ELECTRONIC 2022 INTEGRATED)	
RESOURCE PLAN OF EAST KENTUCKY)	CASE NO.
POWER COOPERATIVE, INC.)	2022-00098

RESPONSES TO JOINT INTERVENOR'S SUPPLEMENTAL INFORMATION

REQUEST TO EAST KENTUCKY POWER COOPERATIVE, INC.

DATED AUGUST 30, 2022

Lamb Testimony Exhibit 1
Summary of Power Flow Analysis for Simultaneous Outages of Cooper Units 1 and 2

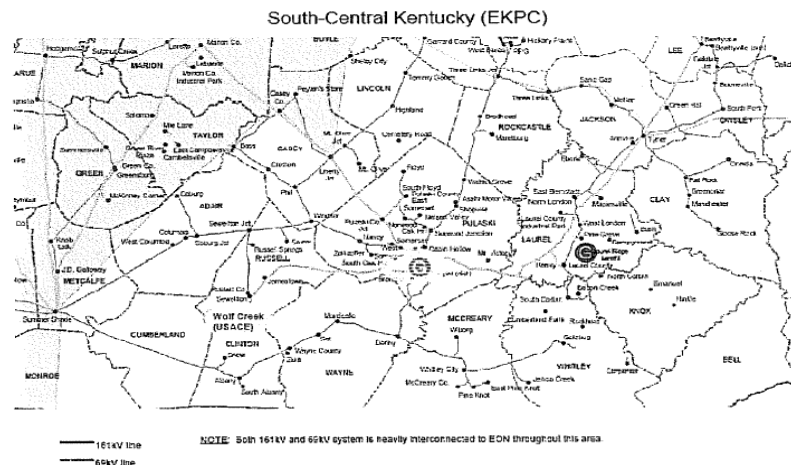
Request 21a. Approximately when did EKPC first become aware of that "the current transmission system is not configured to support the peak load periods in that region without the generation injections at Cooper Station"? Please provide the approximate month and year.

Response 21b. See Exhibit 1 to testimony submitted by James C. Lamb, Jr. in EKPC’s Application for a CPCN for construction of modifications to the water intake system at Cooper Power Station (Case No. 2007-00168) provided below.

Power flow analyses of EKPC’s 2007 Summer and 2007/08 Winter peak system models were performed to ascertain the ramifications of potential outages of the Cooper Station generating units. The south-central Kentucky area demand is met by four primary sources – the Cooper Station generating units, the Wolf Creek Dam generating units, the E.ON U.S. 345/161 kV transformer at Alcalde, and the Wolf Creek TVA-Russell County-Cooper 161 kV line. Additional support is provided to the area by the following EHV elements – the E.ON U.S. Pineville 345/161 kV transformer, the E.ON U.S. Pocket 500/161 kV transformer, and the Pocket (E.ON U.S.)-Phipps Bend (TVA) 500 kV line. As part of its normal planning process, EKPC evaluates an outage of any one of these sources to determine if transmission system reinforcements are required. EKPC also designs its system for an outage of any single generating unit in conjunction with an outage of a transmission line and transformer. Therefore, in this area EKPC evaluates an outage of Cooper Unit #2 plus an outage of any single line or transformer. However, due to the possibility of decreased water levels for Lake Cumberland that could eliminate the needed water source for the Cooper generating units, the possibility exists that both units could be off simultaneously during the summer. The transmission system must be designed to withstand an additional contingency for this scenario. Furthermore, the U.S. Army Corps of Engineers has informed EKPC that the hydroelectric generating units at the Wolf Creek Dam would be unavailable if the Lake Cumberland water level is lowered below 673 feet. This would eliminate an additional generation source for the area.

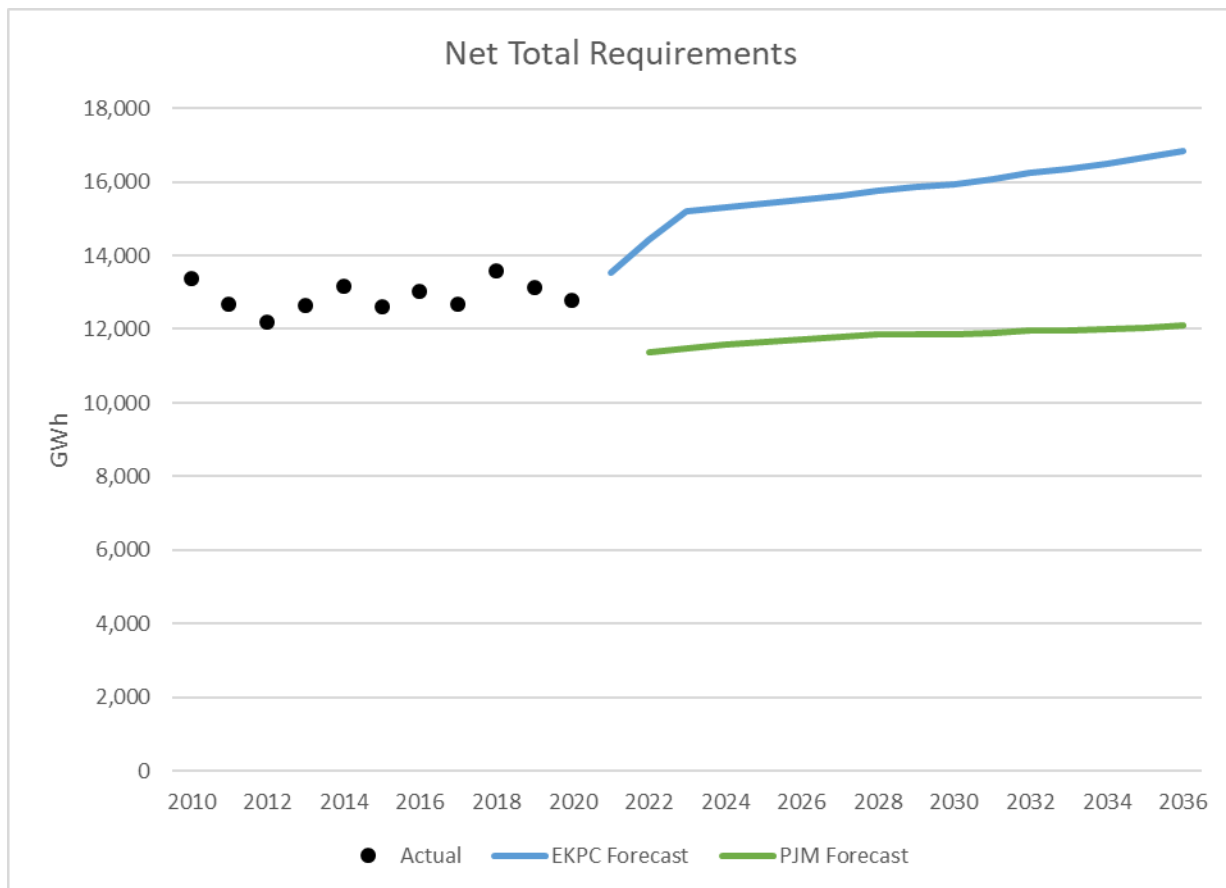
Request 37. Please refer to EKPC response to Joint Intervenor Request No 1 – Figure 1-1, Figure1-2, Figure_1-3, Columns E and S of the tab “Data for Graphs”. The 2022 PJM Load Forecast Report projects 0.4% growth in total annual energy requirements between 2022 and 2036, and 0.4% growth in the winter peak load demand for the same period. EKPC projects growth rates of 1.1% for total annual energy requirement, and 0.6% for its winter peak demand. Can EKPC explain the difference between its forecasts of winter peak load and total energy requirements and PJM’s?

Response 37. The PJM and EKPC forecasts are not the same series. EKPC’s forecast is developed according to its work plan and the requirements of RUS. Economic assumptions are based on owner-member share of county-level projections. Appliance saturations are based on an end-use survey as required by RUS. The EKPC forecast also incorporates known changes to industrial Customers. These assumptions may not be the same as the PJM load forecast. Additionally, the resulting forecasts are different. A graph of historical net total energy requirements along with the EKPC and PJM load forecast are included below. The PJM forecast

is below historical actual indicating that it is not comparable to the EKPC total energy requirement forecast. The PJM forecast is for the load tied directly to the EKPC transmission system. It includes some load for LG&E/KU which is served from the EKPC system and it does not include the EKPC load that is served from the LG&E/KU transmission system. The two forecasts are not directly comparable without significant modifications to the PJM forecast.
